Planning Application 20/04861/FUL

Comments by Westminster Park Residents' Association

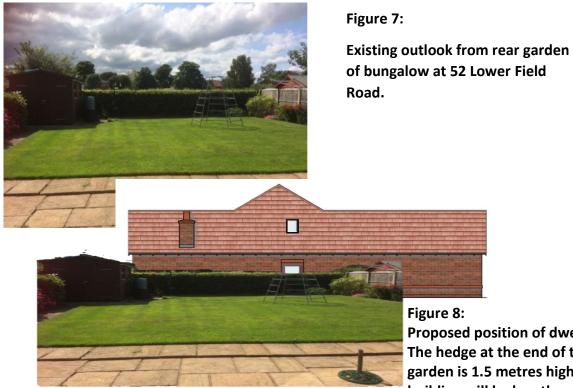
This development will have huge visual impact on the outlook from existing neighbouring properties and, for some, an unacceptable loss of privacy due to the overlooking of their main habitable rooms. The Building Research Establishment states that, **"Sensitive design should provide sufficient daylight and sunlight to new housing while not obstructing light to existing homes nearby."**

The impact is exacerbated by overly tall house designs and being sited very close to the boundaries of existing properties, as the following examples illustrate. The ridge height - according to the scale bar on the elevation drawings - is circa 9m.

Numbers 38, 40, 42, 44, 50 and 52 Lower Field Road and 107 and 107A Lache Lane will be affected particularly adversely by overlooking and loss of privacy. It is proposed to site 2 storey flats and houses at the ends of the rear gardens of numbers 38, 40, 42 and 44. Although the distance between the habitable windows is just greater than the 21 metres required, buildings are positioned less than 3 metres from boundary hedges, meaning that windows overlook existing properties to an unacceptable degree. Owners will lose all privacy in rear facing habitable rooms and gardens.
